CURRENT EXISTING 2ND BUILDING DEPARTMENT SUBMITTAL SET

ROUND BARN VILLAGE

SANTA ROSA, CA

BUILDING TYPE 200 | Slab Edge & 1st Floor Plan Composite

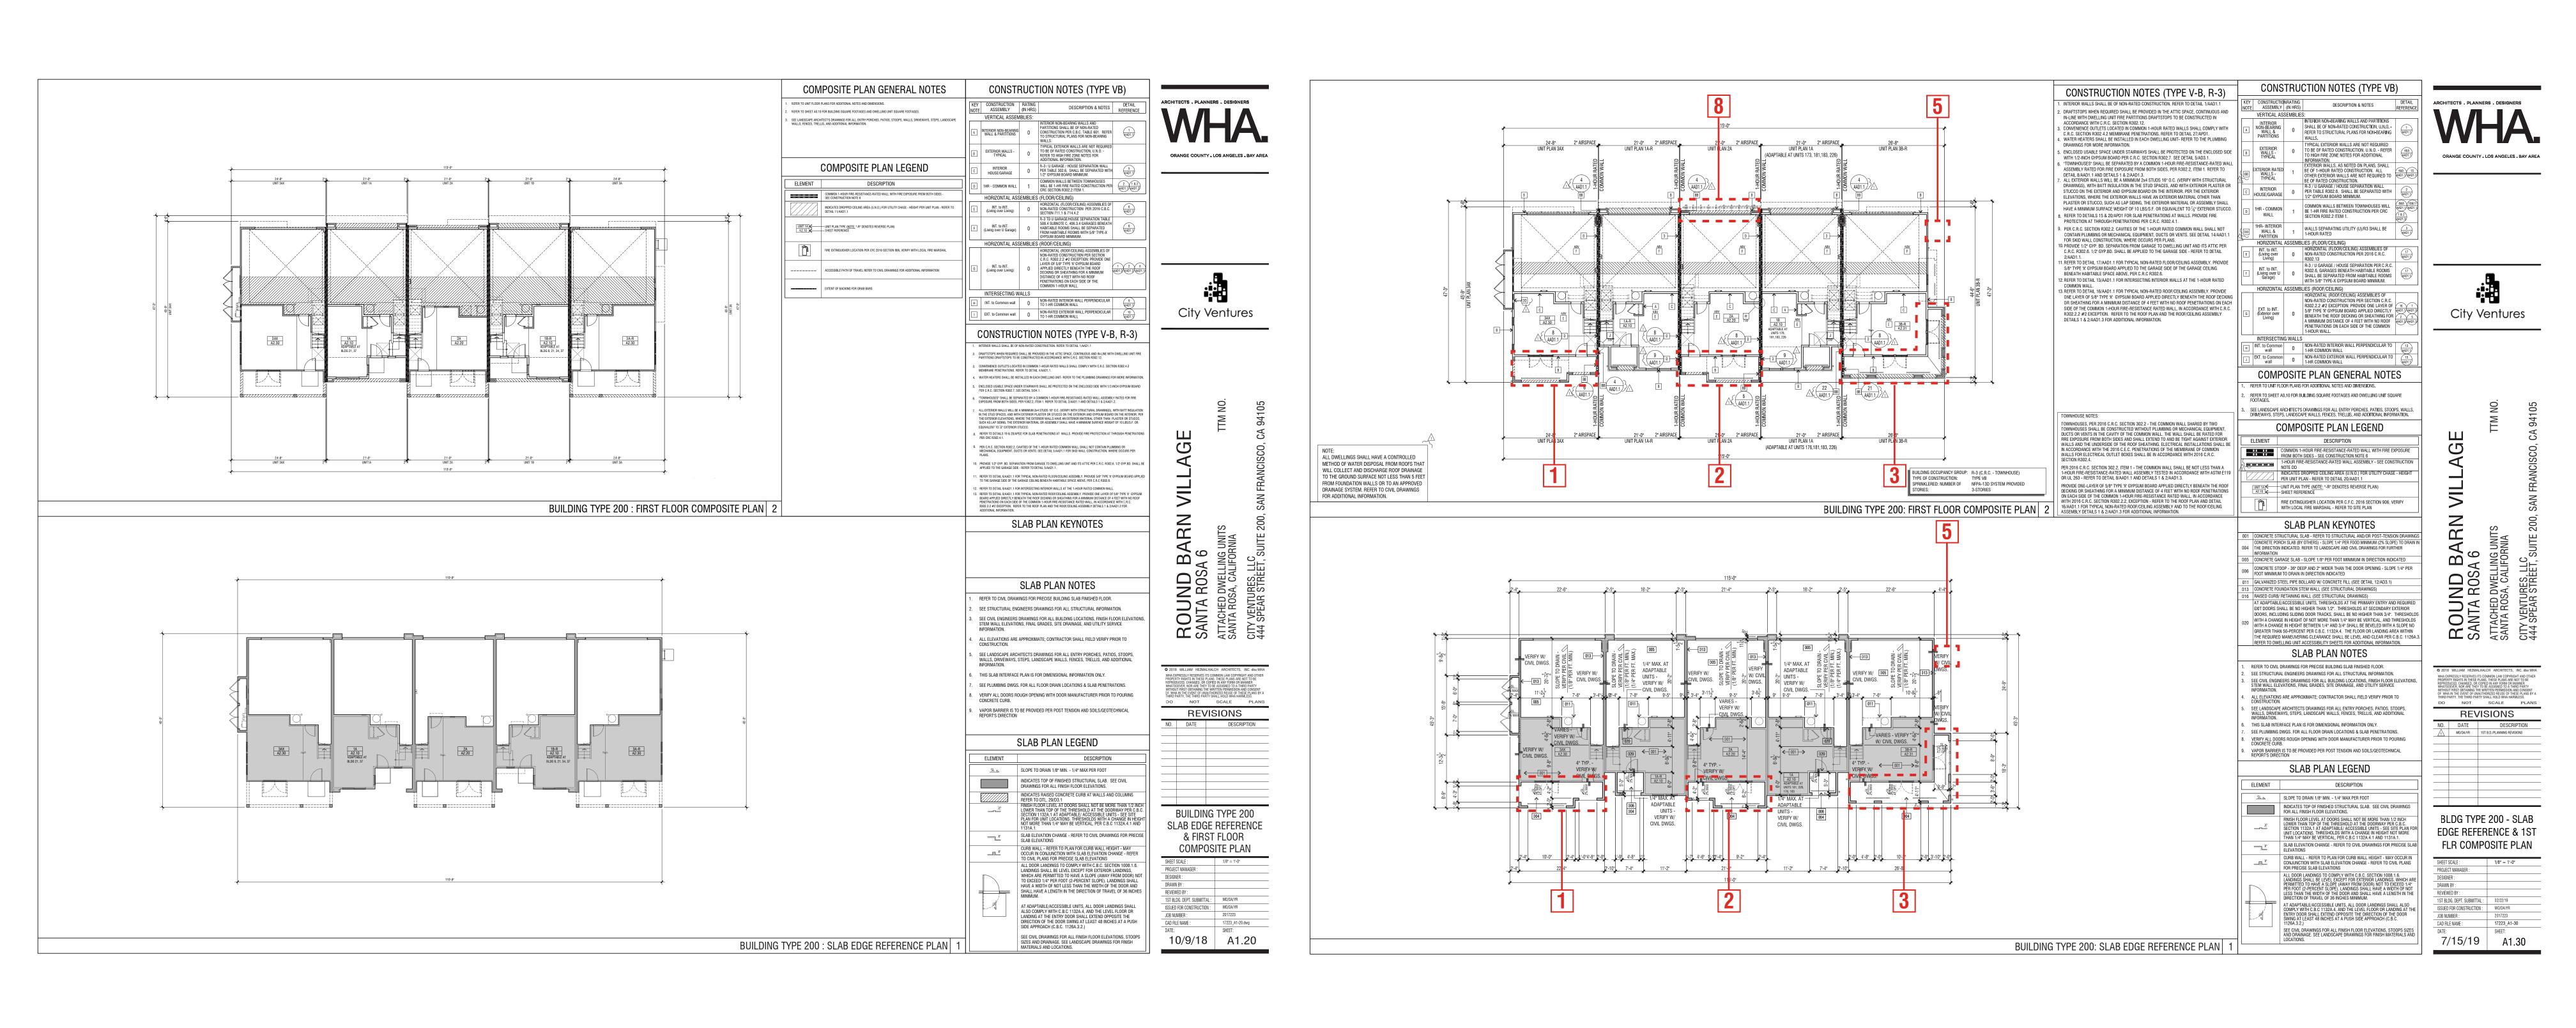
- 1 Unit 3A Added Covered Deck | Created Double Gable | Reconfigured Windows | Removed Awnings Above Windows | Removed / Replaced Horizontal Siding with Boards & Batts.
- 2 Unit 2A Added Covered Deck | Created Double Gable | Reconfigured Windows | Removed Awnings Above Windows | Removed / Replaced Horizontal Siding with Boards & Batts.
- 3 Unit 3B Added Wrap Around Deck / Reconfigured Porch | Added 3050 Window | Added Awning Above Deck Door and Windows at second level
- 4 Added Gable/Sloped Roof
- 5 Removed Ladder
- 6 Revised Second Floor Massing at Kitchen
- 7 Added Awning
- 8 Added Trellis at Unit 2A, Typ.

BUILDING TYPE 200 | 2nd & 3rd Floor Plan Composite

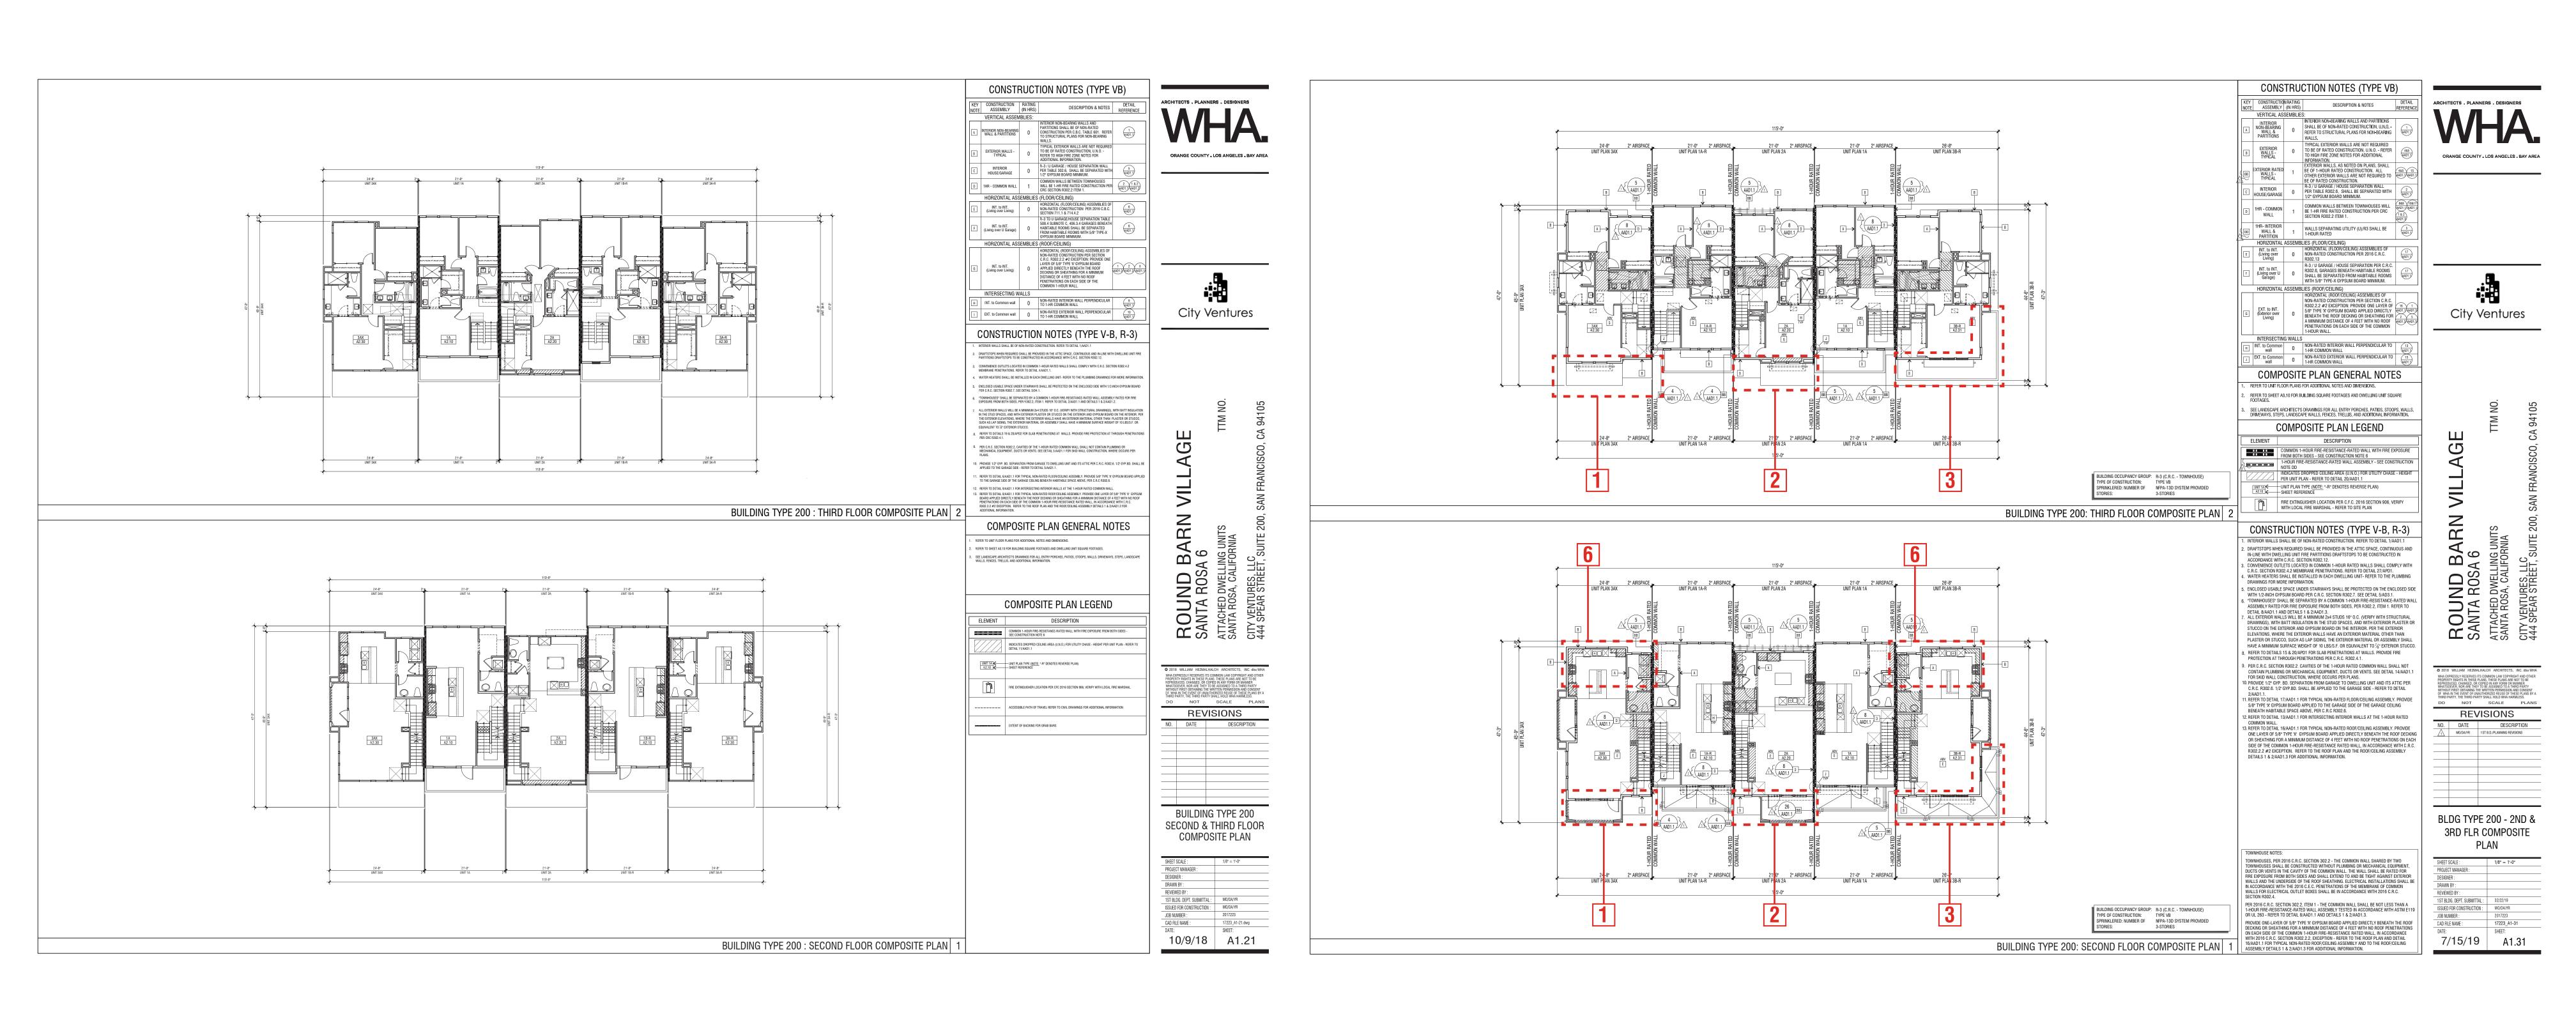
- 1 Unit 3A Added Covered Deck | Created Double Gable | Reconfigured Windows | Removed Awnings Above Windows | Removed / Replaced Horizontal Siding with Boards & Batts.
- 2 Unit 2A Added Covered Deck | Created Double Gable | Reconfigured Windows | Removed Awnings Above Windows | Removed / Replaced Horizontal Siding with Boards & Batts.
- 3 Unit 3B Added Wrap Around Deck / Reconfigured Porch | Added 3050 Window | Added Awning Above Deck Door and Windows at second level
- 4 Added Gable/Sloped Roof
- 5 Removed Ladder
- 6 Revised Second Floor Massing at Kitchen
- 7 Added Awning
- 8 Added Trellis at Unit 2A, Typ.

BUILDING TYPE 200 | Roof Plan

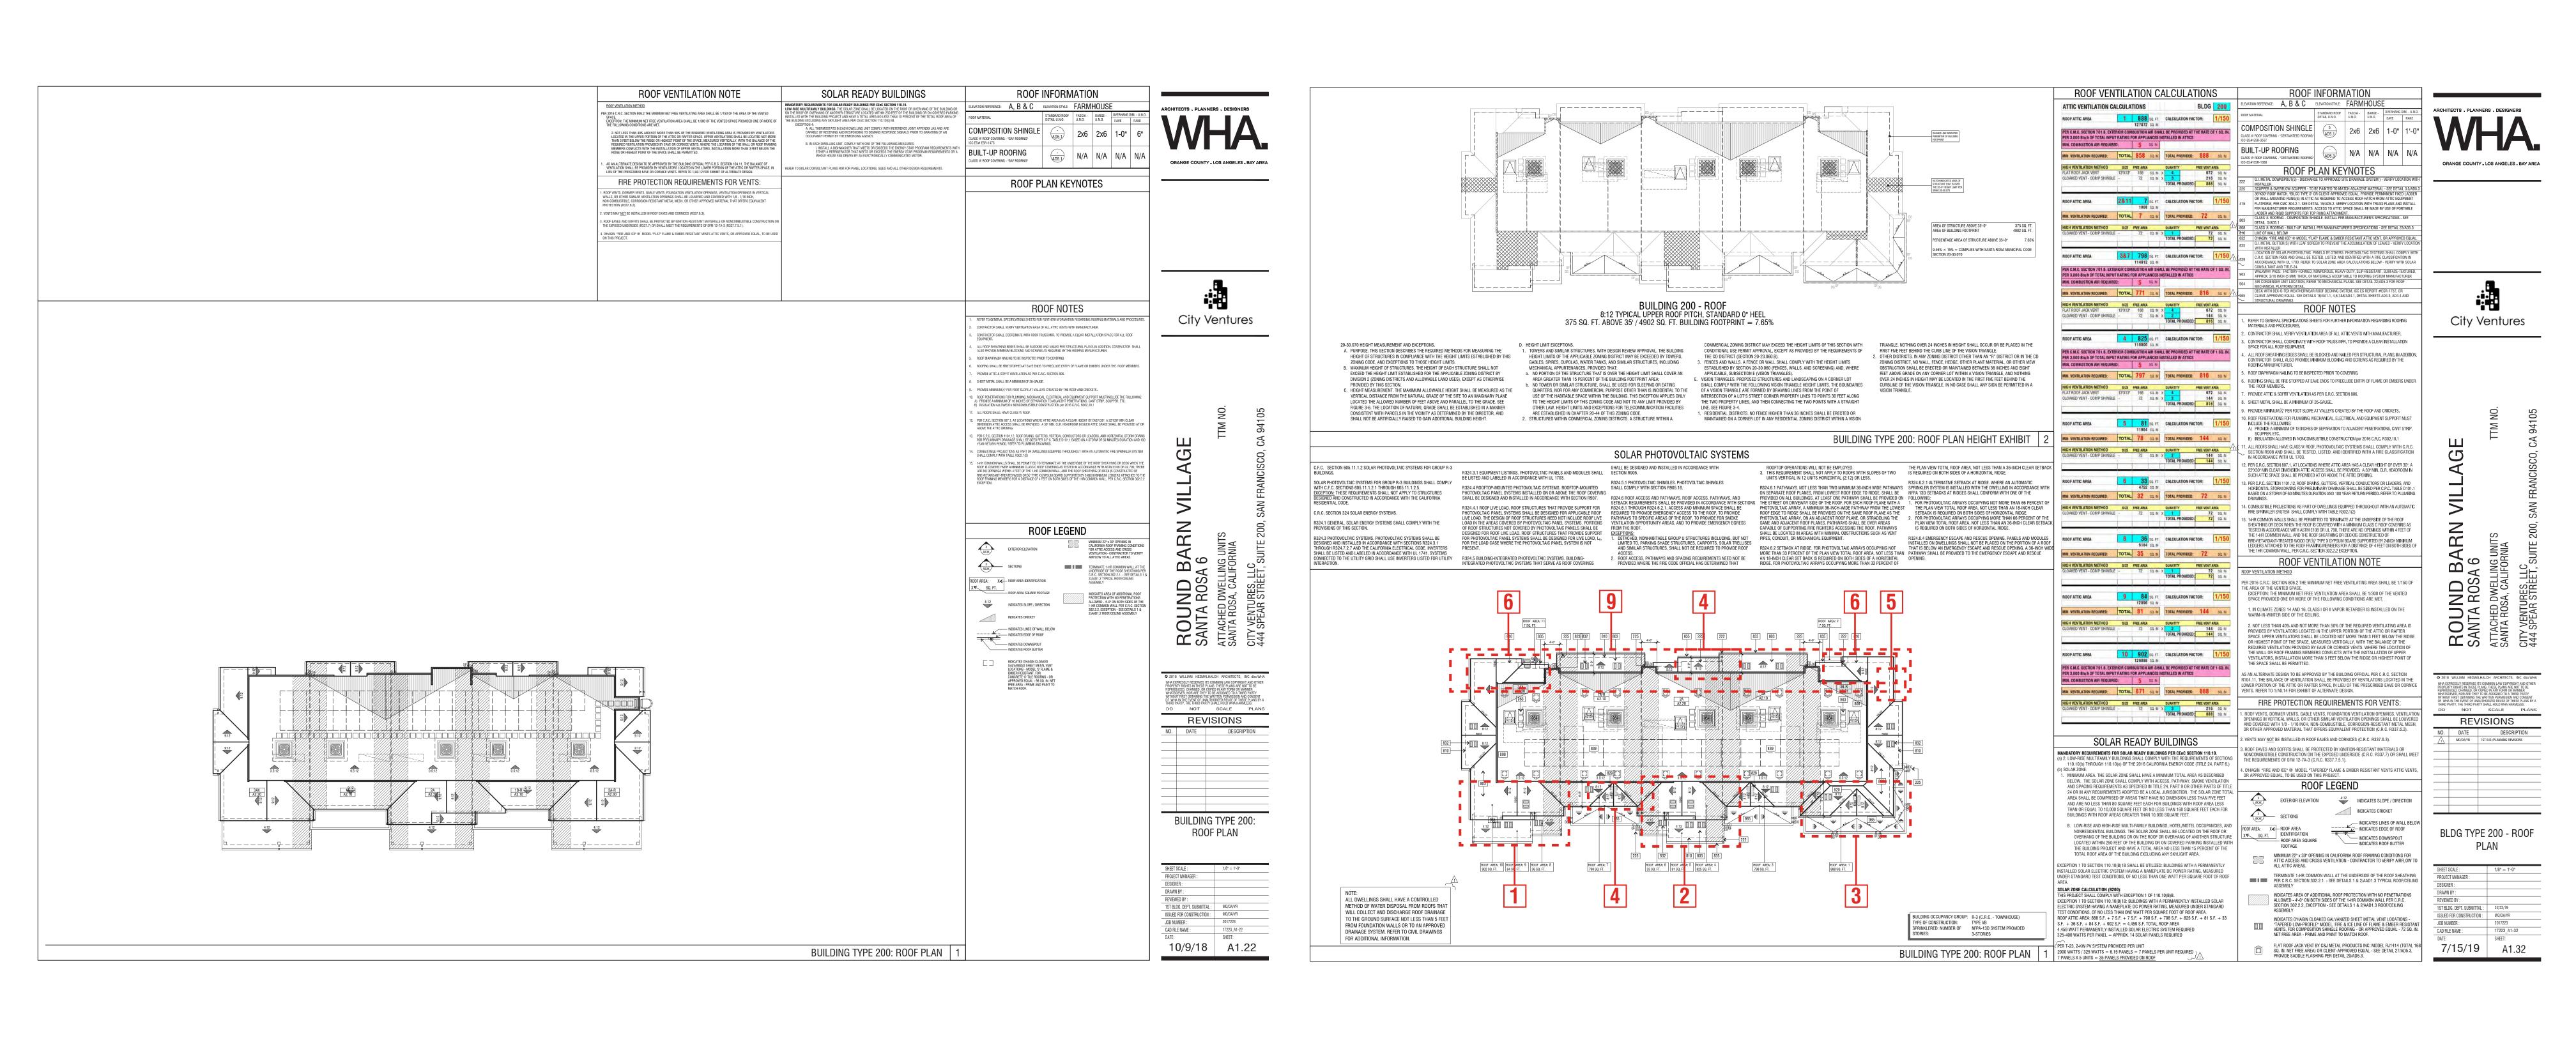
- 1 Unit 3A Added Covered Deck | Created Double Gable | Reconfigured Windows | Removed Awnings Above Windows | Removed / Replaced Horizontal Siding with Boards & Batts.
- 2 Unit 2A Added Covered Deck | Created Double Gable | Reconfigured Windows | Removed Awnings Above Windows | Removed / Replaced Horizontal Siding with Boards & Batts.
- 3 Unit 3B Added Wrap Around Deck / Reconfigured Porch | Added 3050 Window | Added Awning Above Deck Door and Windows at second level
- 4 Added Gable/Sloped Roof
- **5** Removed Ladder
- 6 Revised Second Floor Massing at Kitchen
- 7 Added Awning
- 8 Added Trellis at Unit 2A, Typ.

9 Per City Fire Request The Rear Elevation Roof Design Has Been Modified

BUILDING TYPE 200 | Style 1 Exterior Elevations

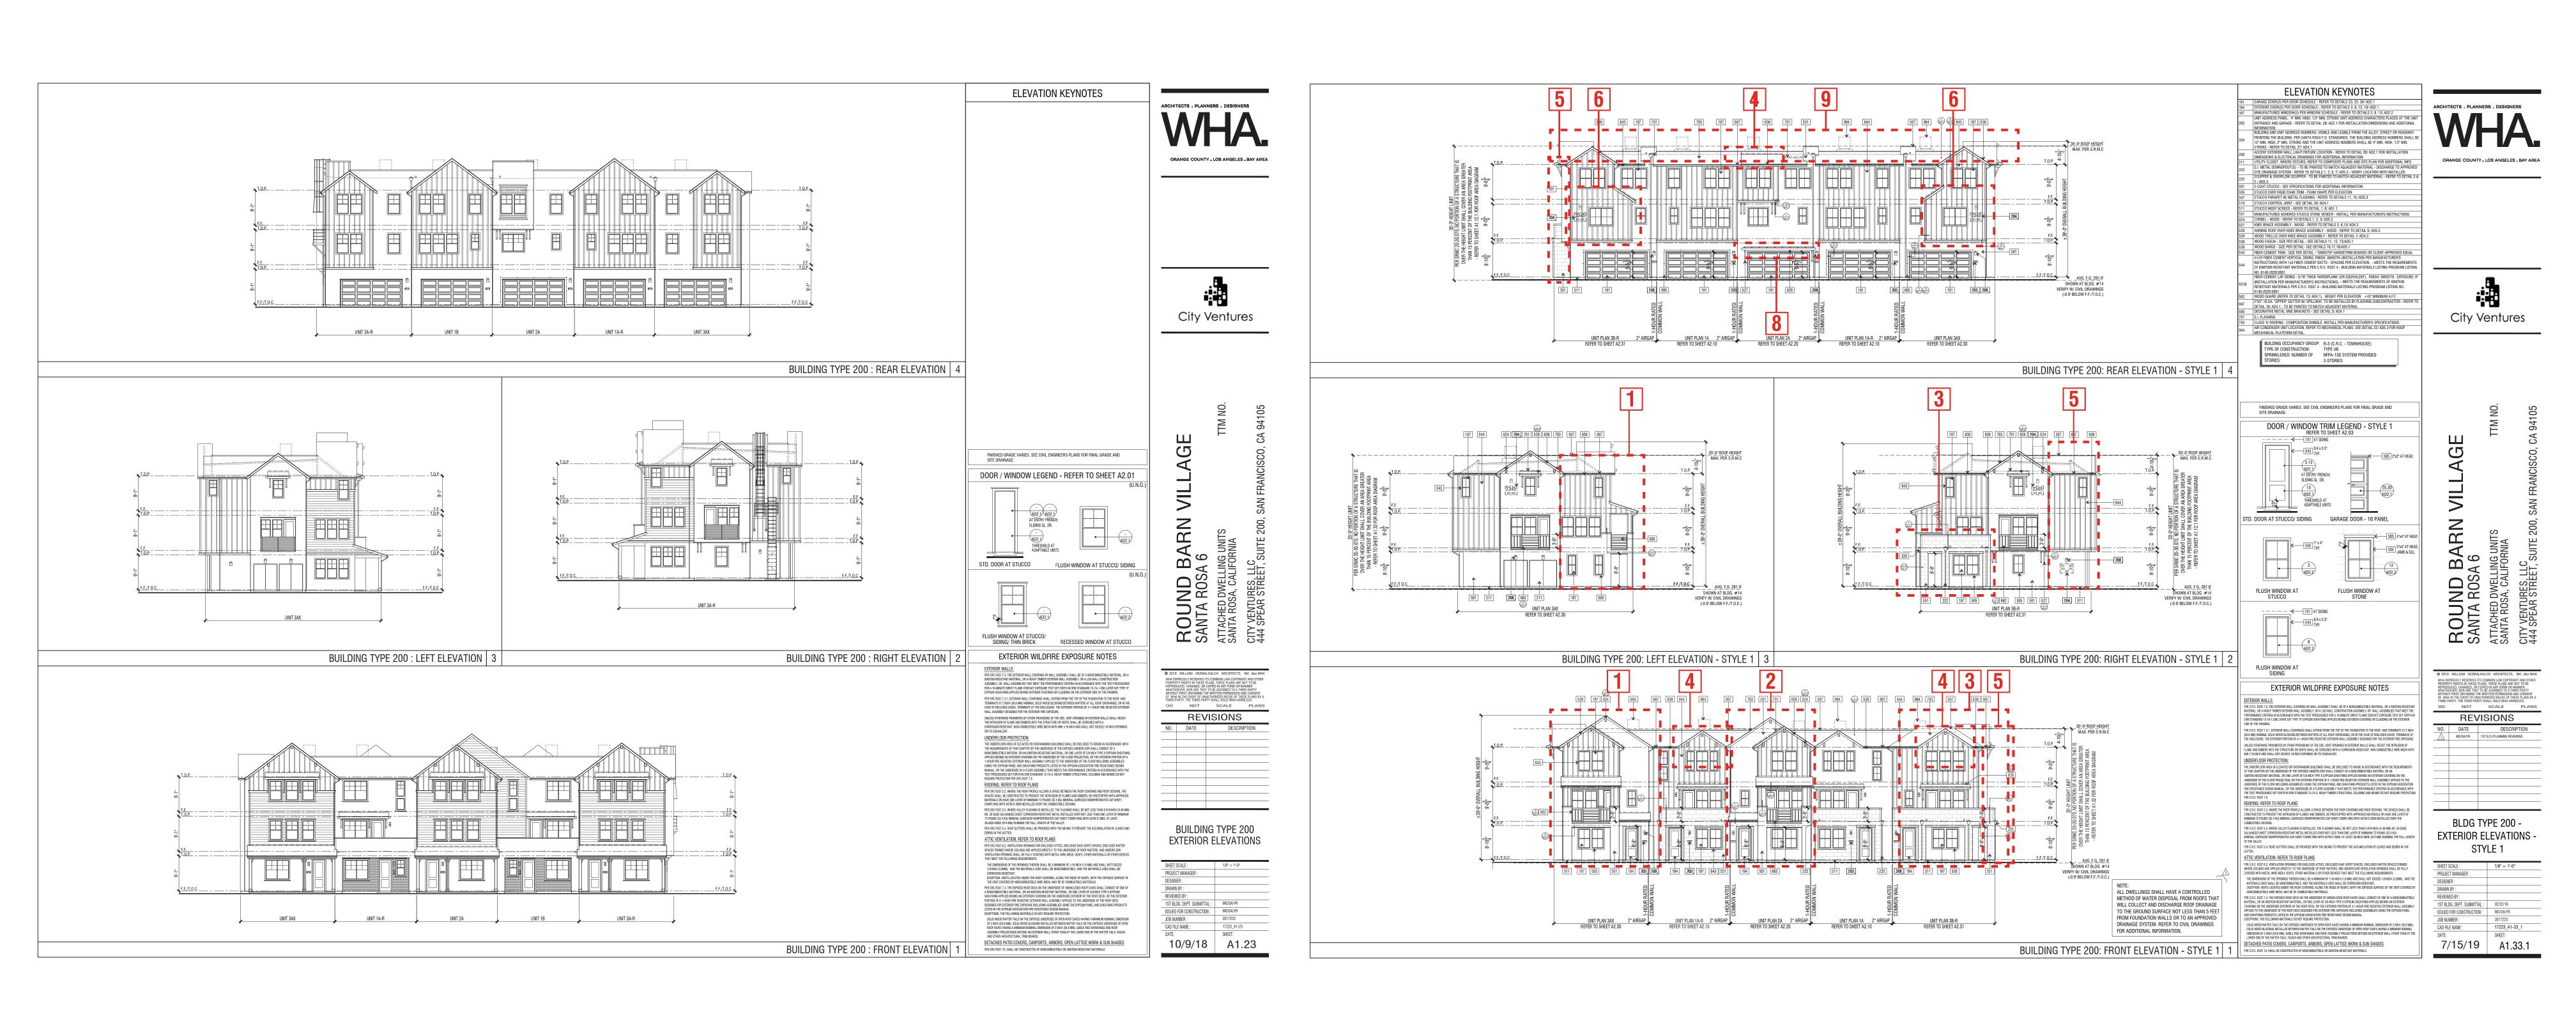
- 1 Unit 3A Added Covered Deck | Created Double Gable | Reconfigured Windows | Removed Awnings Above Windows | Removed / Replaced Horizontal Siding with Boards & Batts.
- 2 Unit 2A Added Covered Deck | Created Double Gable | Reconfigured Windows | Removed Awnings Above Windows | Removed / Replaced Horizontal Siding with Boards & Batts.
- 3 Unit 3B Added Wrap Around Deck / Reconfigured Porch | Added 3050 Window | Added Awning Above Deck Door and Windows at second level
- 4 Added Gable/Sloped Roof
- 5 Removed Ladder
- 6 Revised Second Floor Massing at Kitchen
- 7 Added Awning
- 8 Added Trellis at Unit 2A, Typ.
